Reference: **3355B**
9th January 2020

Arborist Response

**Re: Royal Hall of Industries
Lot 3, (D.P.861843) and Lot 52 (D.P.1041134)
No. 1 Driver Avenue, MOORE PARK**

Appendix A; Plan, Potential Crossover Location relative to trees No. 42-46

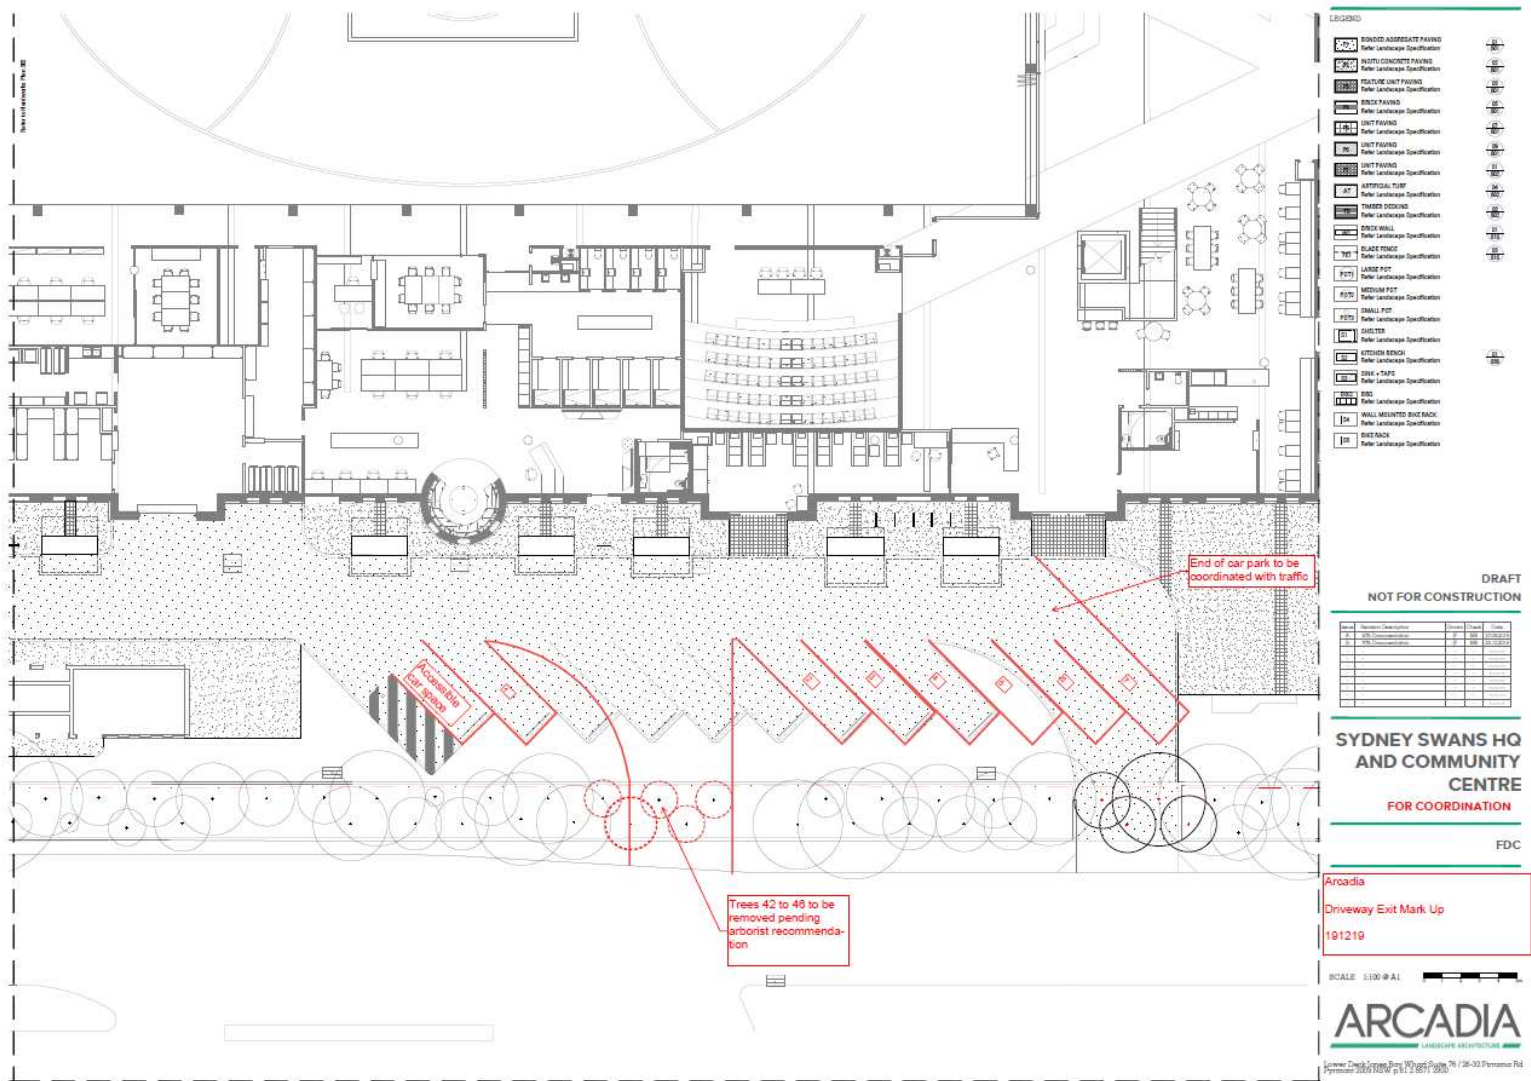
*The City reiterates that Trees 58, 59, and 60 on Errol Flynn Boulevard **must be retained**..... As such, consideration should be made to Trees 42-46, which are of less significance and remove Tree 43 and 45.*

The request for consideration for the removal of trees No. 42-46 in preference to No. 57-60 based on the difference for significance is unfounded. A comparison of the trees

contained in these two sites is summarised in parts of Table 1, (Section 6.0) extracted from the Arboricultural Impact Assessment, and contained in Appendix B (Arborist Response). This data has been assigned an average value for some variables for discussion. Based on the design proposed (Appendix A; Arborist Response) to accommodate the request, tree No. 42 is subject to a minor encroachment (9%) and has been removed from the discussion.

Each option conflicts with four trees (No. 43-46, and No. 57-60) and therefore offer equivalent loss.

The two tree groups provide an average difference in height of 1m and 30mm between the Dbh values. That is, the trees No. 57-60 provide a marginally higher average value. The vitality/SULE rating between the two groups provides a single tree, No. 57, which offers limited life expectancy and could be removed irrespective of the proposed works. Although, the tree group 43 to 46 offers a single tree of SULE rating, A3 which does not constitute removal based on condition. That is the tree group No. 57-60 can be considered to require the removal of three of these four trees based on the limited SULE rating. Both tree groups cater to an equivalent tally for the significance rating (STAR). Other variables for consideration consist of the crown class and bias. Trees No. 43-46 has three of the four trees rated as 'forest class' and a 'symmetrical' crown mass, which offers specimens of typical form. Unlike the crown bias and 'co-dominant class' for trees No. 58-60. Although the habits related to either tree group is not considered to offer any significant risk, the amenity value based on the atypical habit could be considered to impede the significance rating.

In conclusion, the difference in the average size of these two tree groups is considered as negligible, although the assigned ratings and habits refer to the trees No. 43-46 to offer marginally increased amenity value. Both tree groups are considered from an arboricultural perspective to maintain equivalent significance, and the assigned significance ratings applied in the Arboricultural Impact Assessment are valid.

That is, no difference exists regarding the loss of either trees No. 43-46 or 58-60, and therefore the design should be influenced by the practical location for the cross-over.

Photo 11

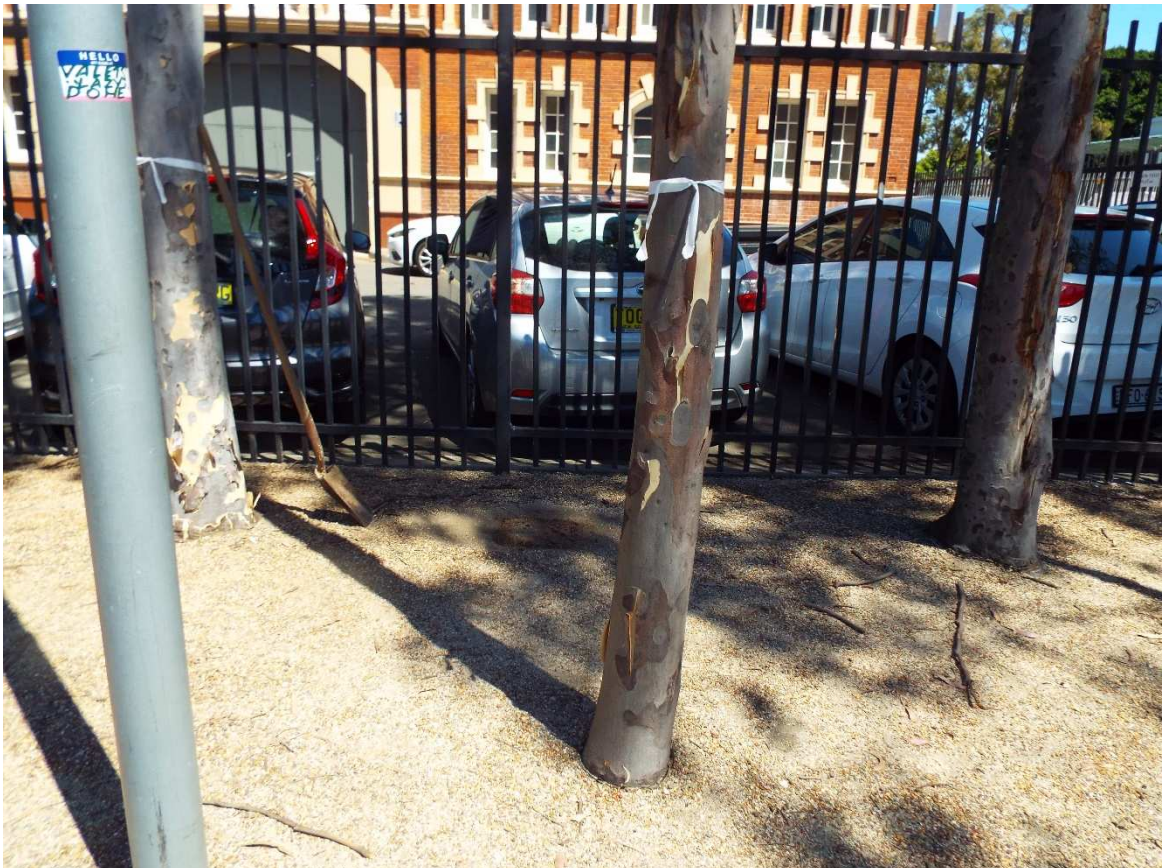
It should be noted that the photos of excavation (test pits) within the TPZ of Trees 56-61 have not been provided. Observation 4 of the Arborist Addendum states that the photos are available on request. These photos must be submitted to assess the impacts of excavation.

A file has been issued containing these photos. These photos are contained in Appendix C, Arborist Response.
